Determination 2008/83

Access for people with disabilities to a viewing platform at 120 Bath Road, Riverton North

Figure 1: Plan showing the viewing platform

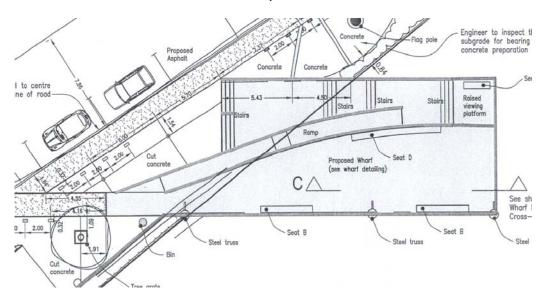
- 2.2 The top platform is 3.0 metres long x 3.3 metres wide, and is 450mm higher than the third level. The structure incorporates a curved access ramp ("the ramp") which runs from the wharf to the third level. Three steps connect the third level and the top platform. The ramp finishes approximately 3.0 metres from the steps leading up to the top platform.

No accessible view area. People whose eye level is lower than 1100 are entitled to have an unobstructed view of the available vistas, from the main levels.

The ramp does not continue to the highest level of the platform.

The plans show that the landing at the top of the ramp (the level 3 platform) clearly meets this requirement.

- 8.1.8 The ramp as constructed terminates at the third level, which is only one of the four levels that could be considered as spaces where people are expected to visit. However, the ramp is also at the same level as the two lower platforms at stages of its incline.

- 8.1.10 However, the barrier provided by the steps from the third to the top level prevents persons in wheelchairs from accessing the top platform. In my opinion this lack of access is contrary to the requirements of Clauses D1.3.2(b) and (c), and leads me to conclude that the viewing platform in its current configuration does not comply with the requirements of the Building Code.

- 9.1 In accordance with section 188 of the Act I hereby determine that:
 - (a) the viewing platform as presently constructed does not comply with Clause D1.3.2 of the Building Code, and
 - (b) the authority's decision to issue a notice to fix that excluded a requirement to provide wheelchair access to the top level of the viewing platform is reversed.
